1963 - 1967 Corvette: Service Bulletin: Fuel Gauge System Diagnosis

Subject: Fuel Gauge System Diagnosis

Source: Chevrolet Technical Service Bulletin

Bulletin Number: DR #752, Section VIII

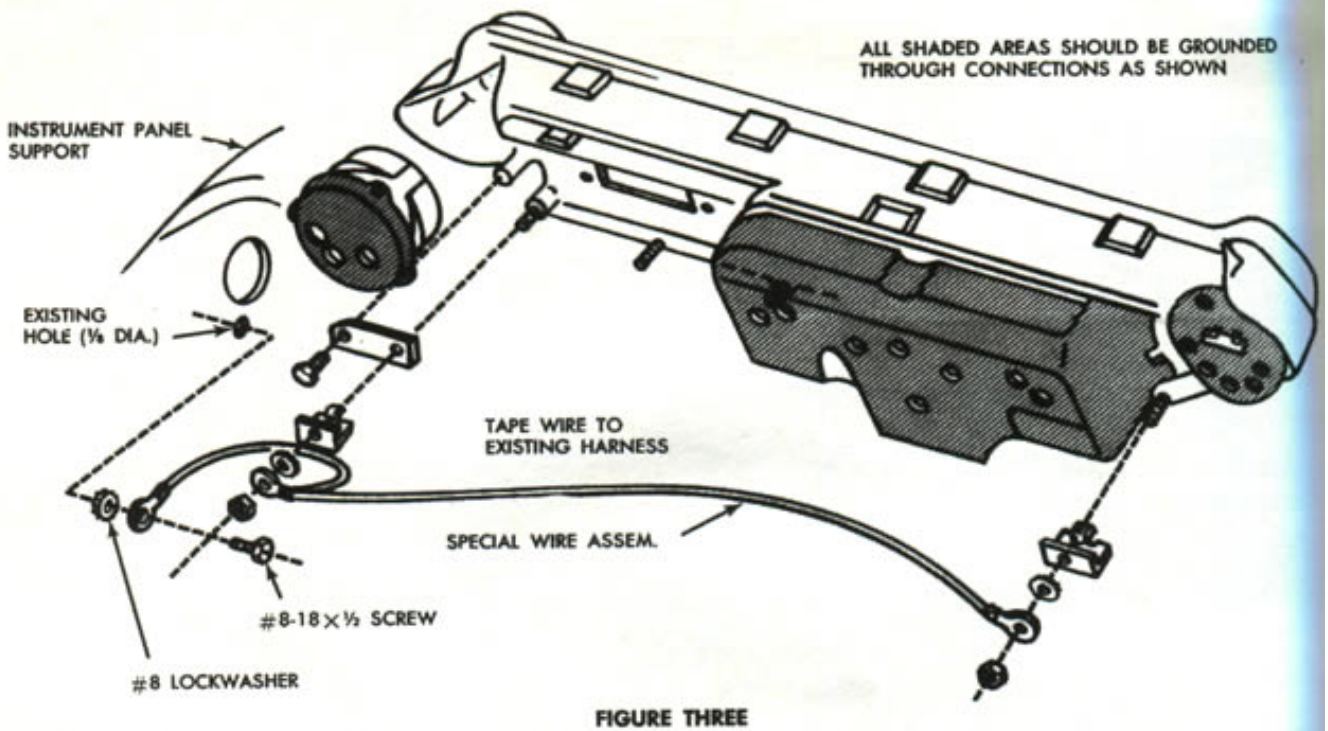
CAUTION: In the above procedure, there is a possibility of breaking the solder joint where the suction tube passes through the mounting plate. If this occurs, or if a new tank sending unit is installed on tanks without the orange paint identification, the replacement sending unit should be reworked per Figure 1 (Page 6) prior to installation.

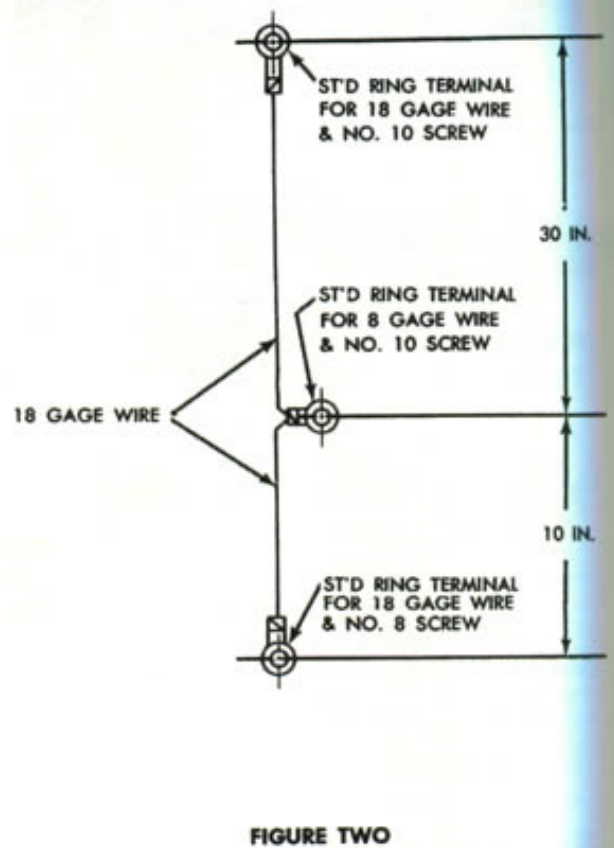
If ground circuit correction is needed, make a ground wire assembly as shown in Figure 2, Page 6. Install as shown in Figure 3, Page 6.
